**ADDENDUM NUMBER 2:
NEW HAMPSHIRE COOPERATIVE RECYCLING FACILITY
CONTRACT DOCUMENTS AND TECHNICAL SPECIFICATIONS**

**Issued: October 18, 2011
For Bids Due: October 26, 2011**

Sheet: 3 of 10
Drawing no.: C-3

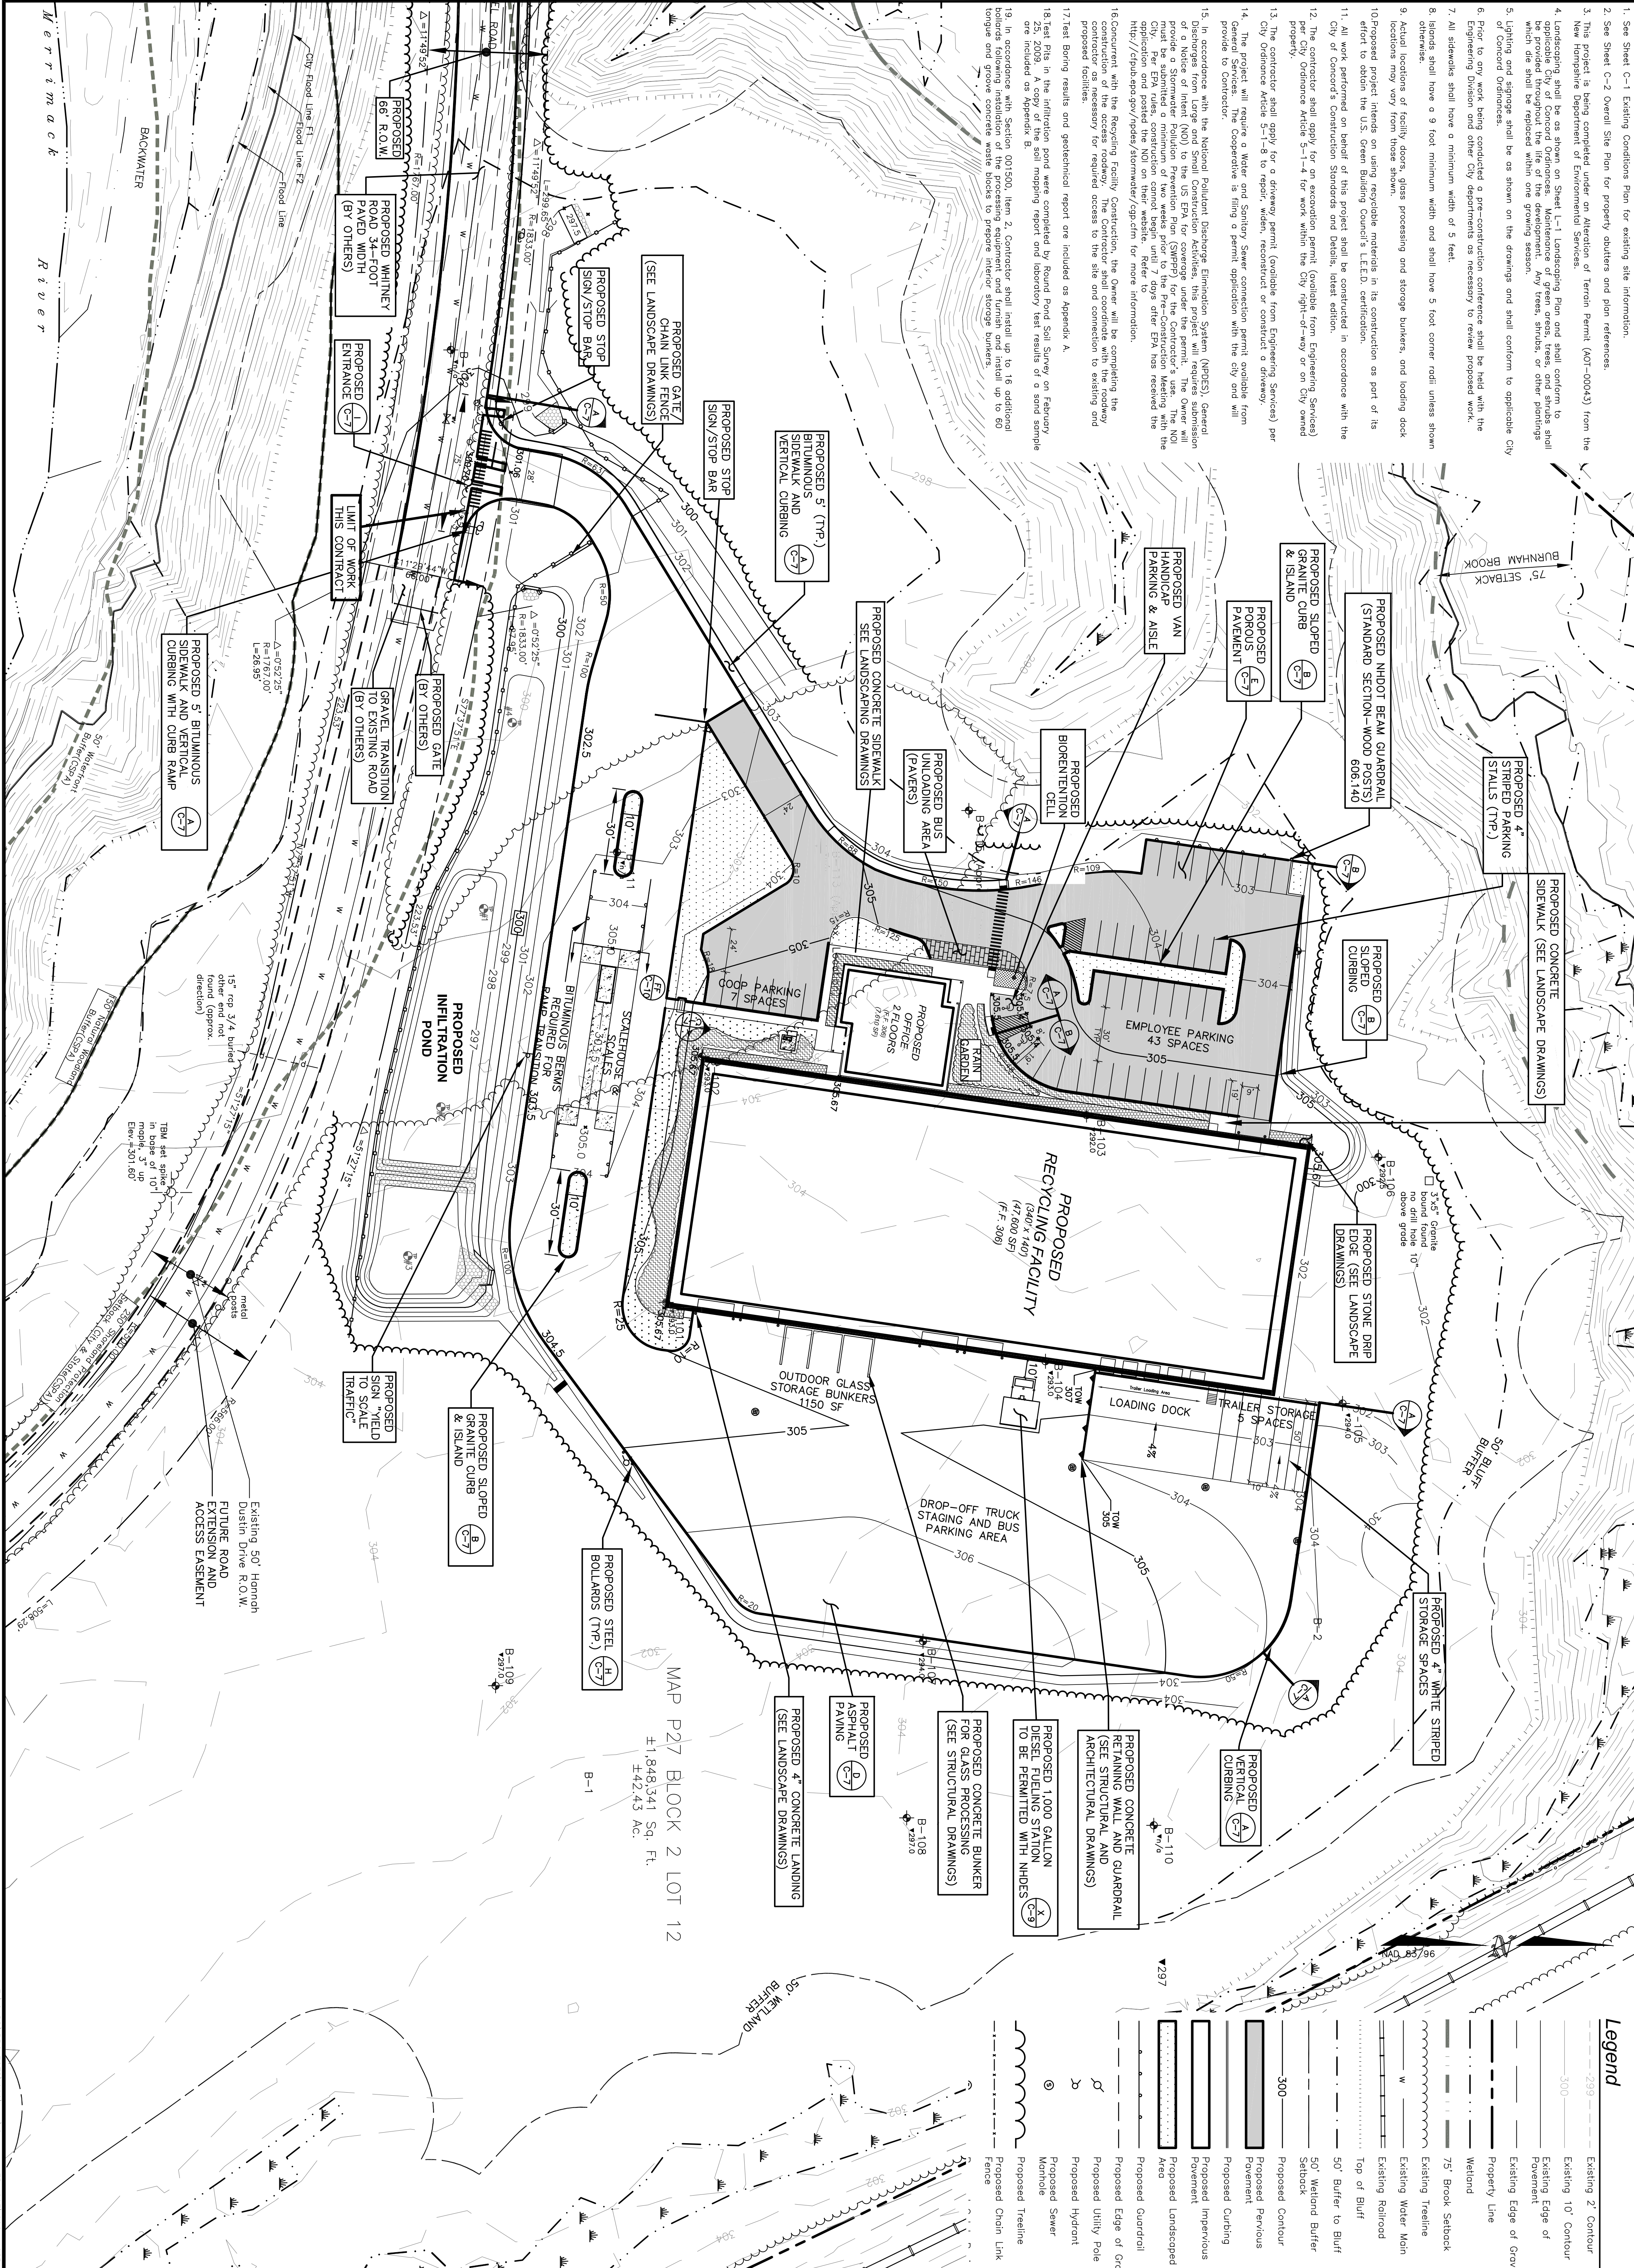
a. *Replace Existing Drawing with Drawing Revised Per Addendum No. 2 to indicate Access Roadway Contractor is to complete the water line adjustment, hydrant, and 8" water service and sewer service lateral to the limit of the Right-of-Way.*

b. *Drawing is also revised to Add Note 18 to Read as Follows:*

c. *Drawing is also revised to include revisions to the pavement limits at the northwest corner of the facility to provide access to a 12' x 14' overhead door. Landscaping revisions also include concrete pavement at revised personnel door location. These changes will also affect the landscape, architectural, structural and mechanical drawings for this area.*

18. In accordance with Section 001500, Item 2, Contractor shall install up to 16 additional bollards following installation of the processing equipment and furnish and install up to 60 tongue and groove concrete waste blocks to prepare interior storage bunkers.
